File 1990-0029

Name 2119 North 7th Street – Resubdivision

TITLE HEADING: ReSub L5 B1 Bookcliff Park

ACTIVITY: Resubdivision

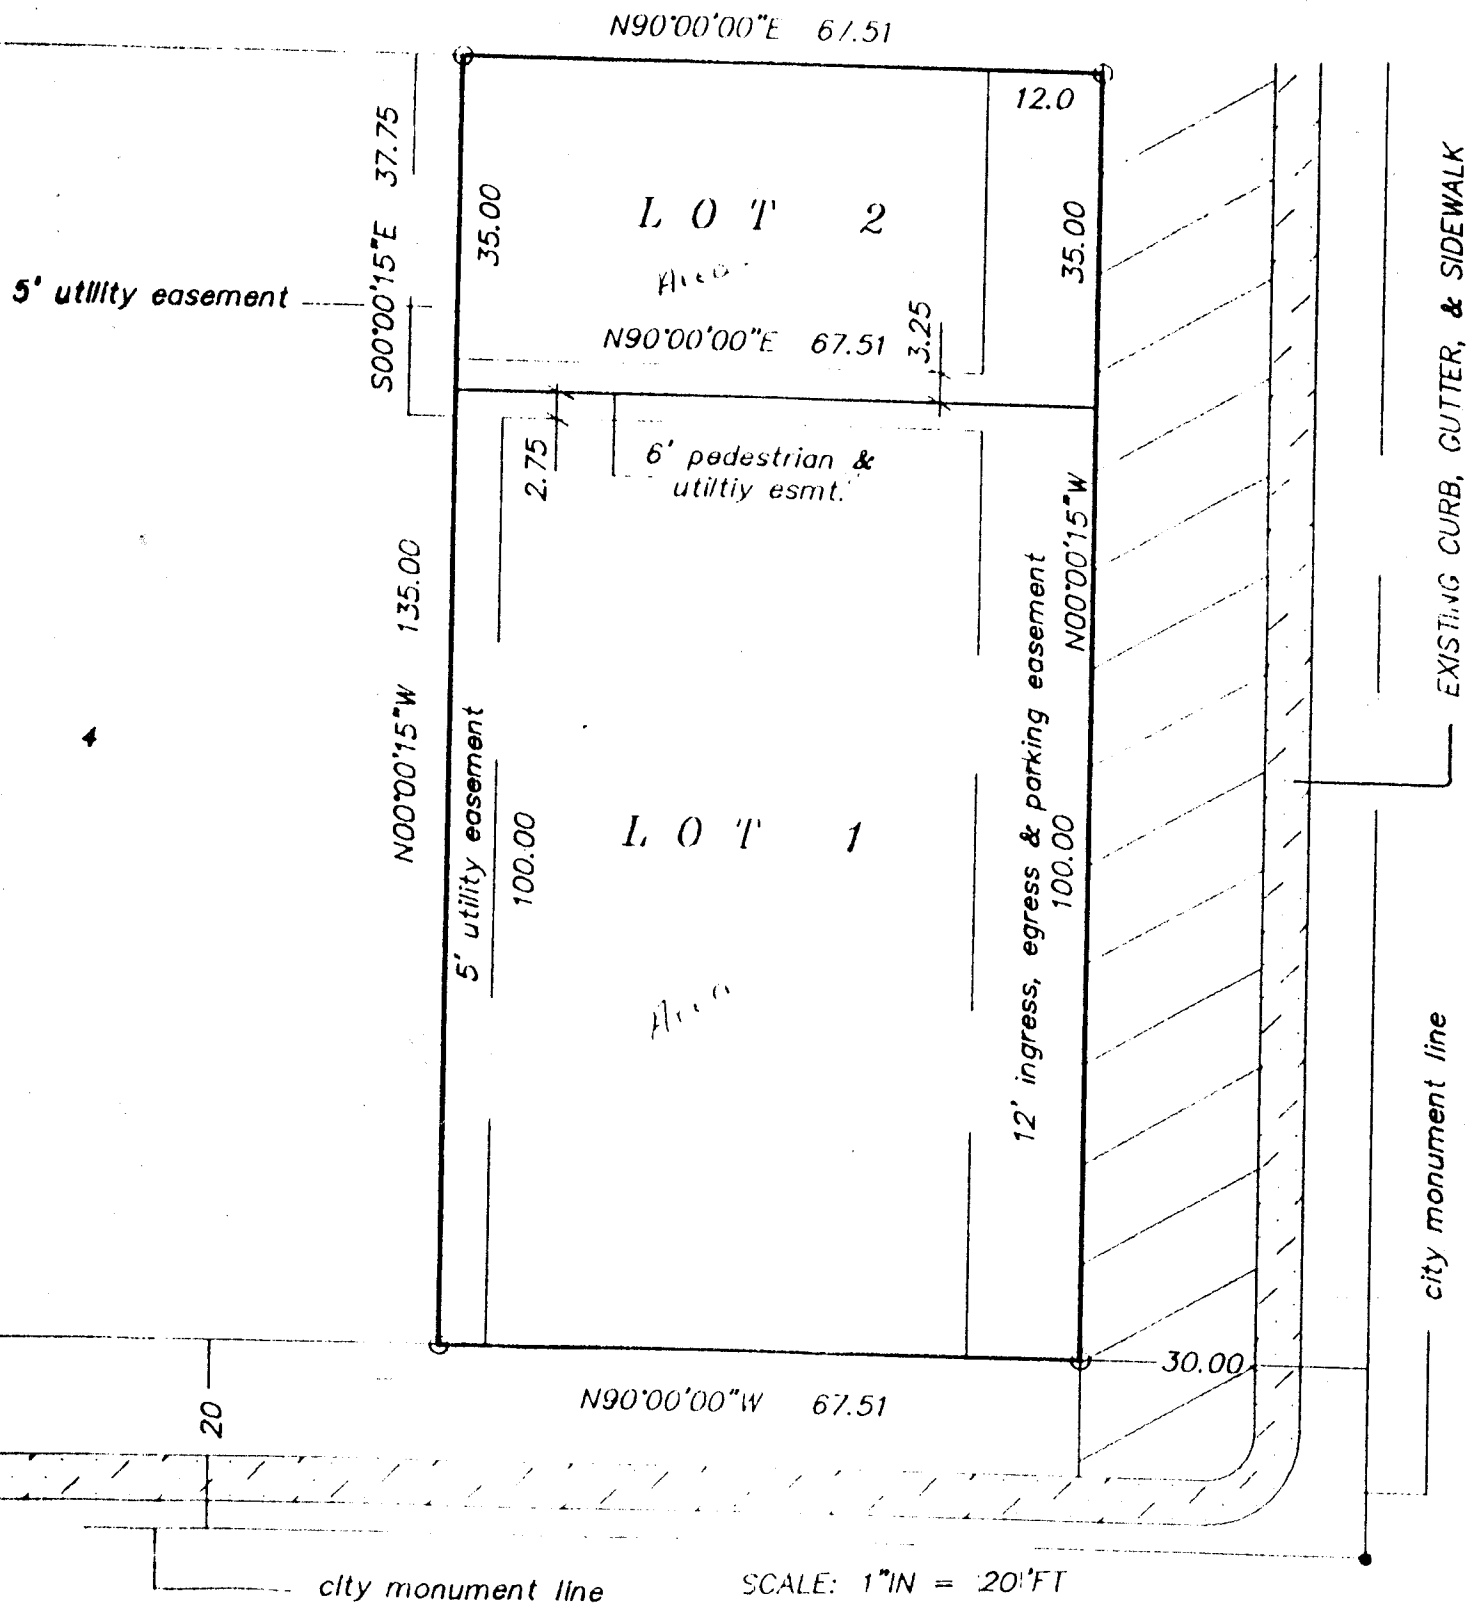
Parking spaces shown in public right-of-way along 7th Street should be removed from the plat. If petitioner desires to continue parking in the right-of-way, a revokable permit will be required.

Also, a bumper block will be required in front of each parking space to prevent vehicles from encroaching onto the pedestrian sidewalk.

Painted parking stalls are required. Submit striping plan for parking to this office for approval.

Plat appears to be creating a 5' wide utility easement across Lot 4. Is this an existing easement? If not, the petitioners probably do not have the authority to create this encumbrance. If this is the case, the easement should be removed from the plat and, if necessary, the easement should be obtained from the owners of Lot 4 by separate deed.

This plat shows the right-of-way for North 7th Street immediately east of this property as being used for parking purposes. I am concerned that approval of the Plat with this delineation would put the City in an awkward position should the right-of-way be needed for road improvements.

I suggest the delineation be removed prior to approval. I also suggest the owners request a Revocable Permit to allow continued use of this area for parking purposes. I will schedule the Revocable Permit request for the July 5 Council meeting.

- A. Parking spaces shown have been removed from the plat.
- B. The revocable permit is tabled on advice of the city attorney and will be addressed in the Appeal of Administrative Decision now ongoing.
- C. Bumper blocks will be installed when the lot split purchase is approved.
- D. Painted parking stall plan is provisionally approved in initial draft. The final draft will contain the changes recommended by Don Newton.

- A. The separate deed is in the process of being prepared for the easment and an agent of the property owners assured us that it will be acceptable.
